**CULTURAL RESOURCES OFFICE
PRESERVATION BOARD
REGULAR MEETING
MONDAY SEPTEMBER 26, 2011
1015 LOCUST ST. #1200
4:00 P.M.**

DATE: September 26, 2011
FROM: Jan Cameron, Preservation Administrator
SUBJECT: Preliminary Review: to construct two commercial buildings and four attached townhouses at alley.
ADDRESS: 3314-3320 Lemp Avenue
JURISDICTION: Benton Park Local and National Register Historic District — Ward 9

DATE: September 26, 2011
FROM: Andrea Gagen, Cultural Resources Office
SUBJECT: Addendum to Permit for New Construction of a single-family residence.
ADDRESS: 1022 Mississippi Avenue
JURISDICTION: Lafayette Square Local Historic District — Ward: 6
PREVIOUSLY HEARD: November 2010

DATE: September 26, 2011
FROM: Bob Bettis, Cultural Resources Office
SUBJECT: Appeal of a staff denial to retain and complete a retaining wall on a Public Façade.
ADDRESS: 3235 Missouri Avenue
JURISDICTION: Benton Park Local Historic District — Ward 9

WEST ELEVATIONS OF PROPOSED TOWNHOUSES (FACING LEMP)

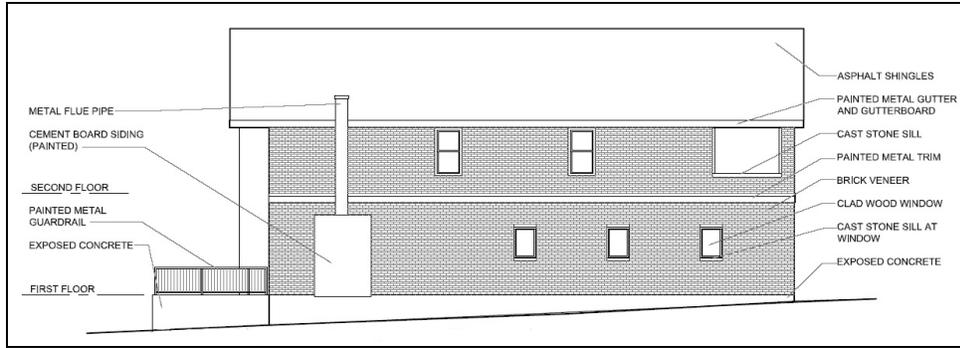
Partly complies. The front and exposed side elevations of the commercial buildings will be brick. The sides of the alley townhouses will also be brick. The front and rear elevations will have portions of painted or stained lap siding; no model example has been submitted.

TOWNHOUSE REAR ELEVATIONS

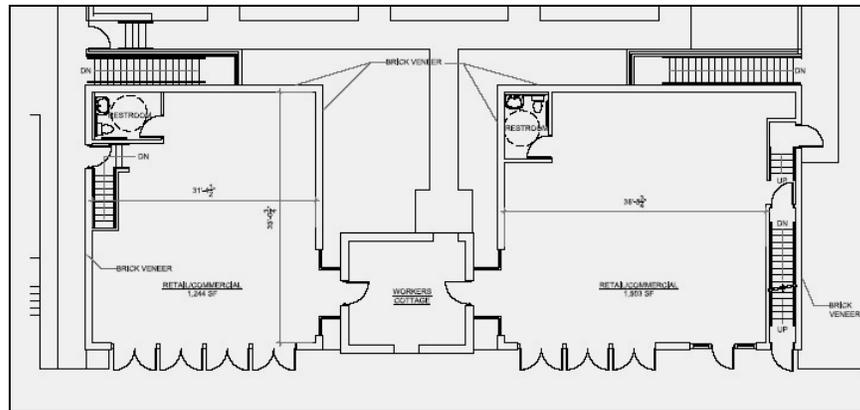
Complies. The rear elevation will have a brick first story with siding above.

DETAIL OF WALL

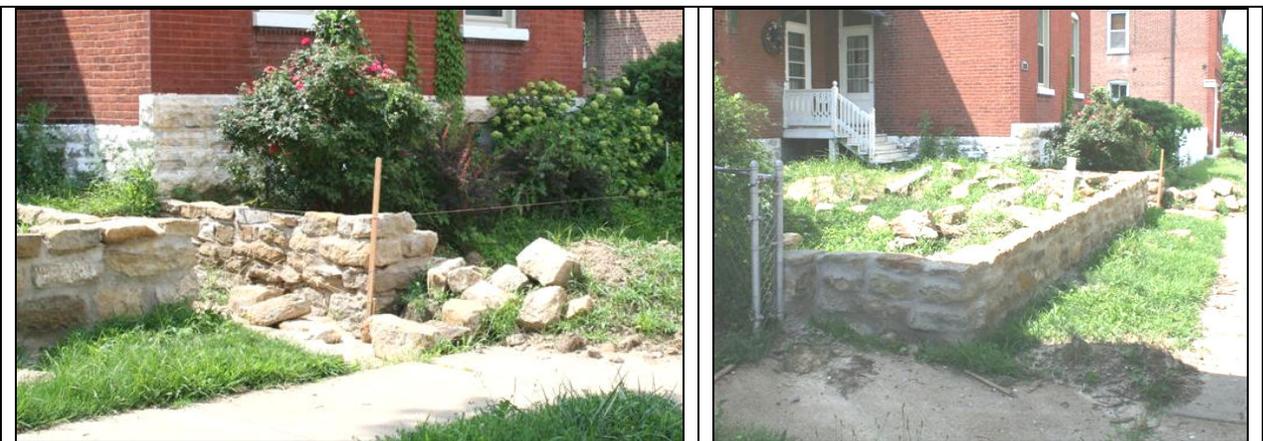
based on a Model Example. The wall, which does not follow any historic Model Example, has a distinctly different appearance due to the fact that the stone in the wall is not a uniform color. In addition, the use of stone of a single size, laid in regular courses, is not typical of historic stone walls in Benton Park. The wide and unraked mortar joints differ from historic masonry as well. Overall, the wall as a whole has a rustic appearance, not the refined character that the historic examples possess.
